From: Caitlin Luo <luoc@ae.ca>
Sent: Thursday, January 19, 2017 8:16 AM
To: Lindsay Poitras
Cc: Carma Holmes
Subject: RE: Photos
Attachments: Harbour Pool-joint on concrete slab.pdf; Harbour Pool-other joints.pdf

We have reviewed the existing structural drawings and the photos you sent. It appears that the joint along grid line 2 is a construction joint within the slab on grade (see the first attachment). The epoxy to be injected at this joint should have capacity to allow some movement.

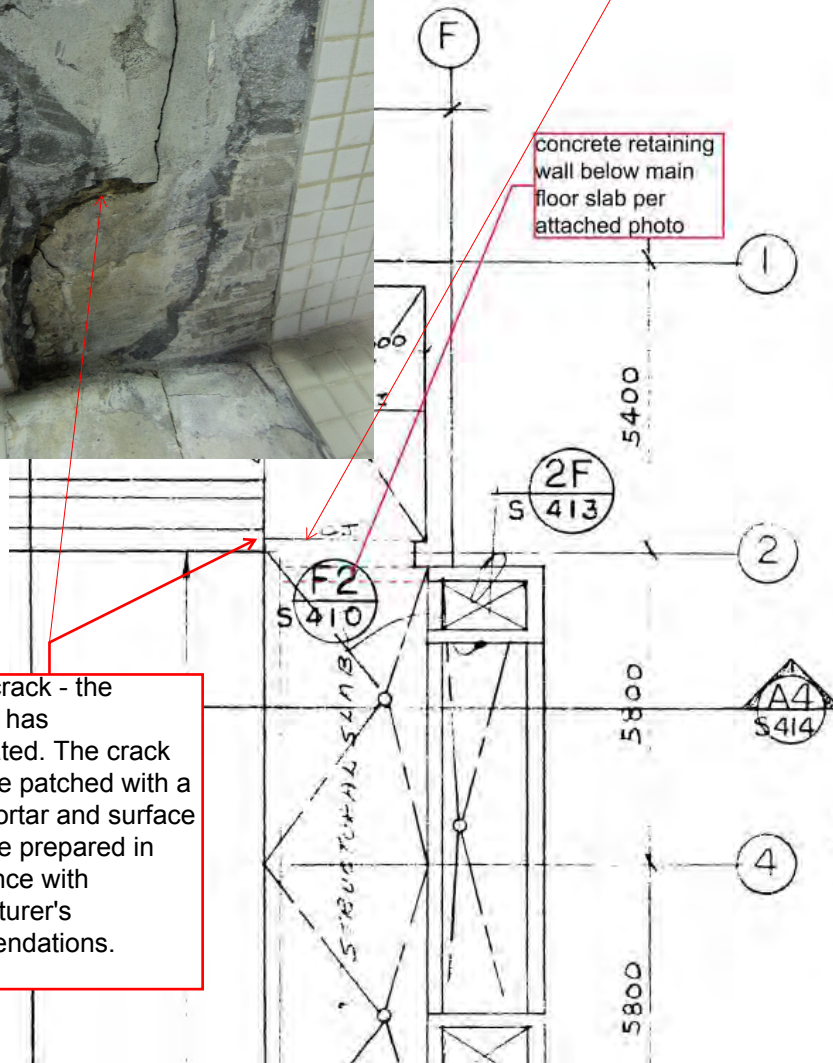
The vertical crack found along the beam at the construction joint should also be repaired.

construction joint

concrete retaining wall below main floor slab per attached photo

vertical crack - the concrete has deteriorated. The crack should be patched with a repair mortar and surface should be prepared in accordance with manufacturer's recommendations.
